City of El Paso - City Plan Commission Staff Report

Case No: SUSU13-00048 Polkinghorn Addition Replat B

Application Type: Resubdivision Combination

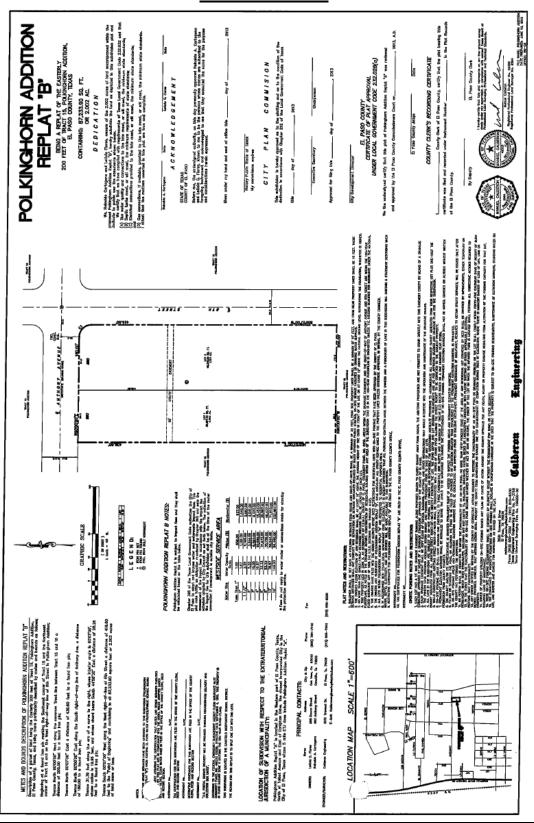
- 1. Show existing grade on all cross sections on preliminary plat sheet.
- 2. Show proposed ROW improvements on sections A & B.
- 3. Section G should show driveway slope.
- 4. Provide sidewalk, header curb, and half of the pavement for 8th Street abutting property limits.
- 5. Provide sidewalk and header curb along Anthony Avenue abutting property limits.
- 6. Line type between lots 1 & 2 should be double dashed regular and boundary bold on final plat sheet.
- 7. Verify dedication statement for ROW improvements.
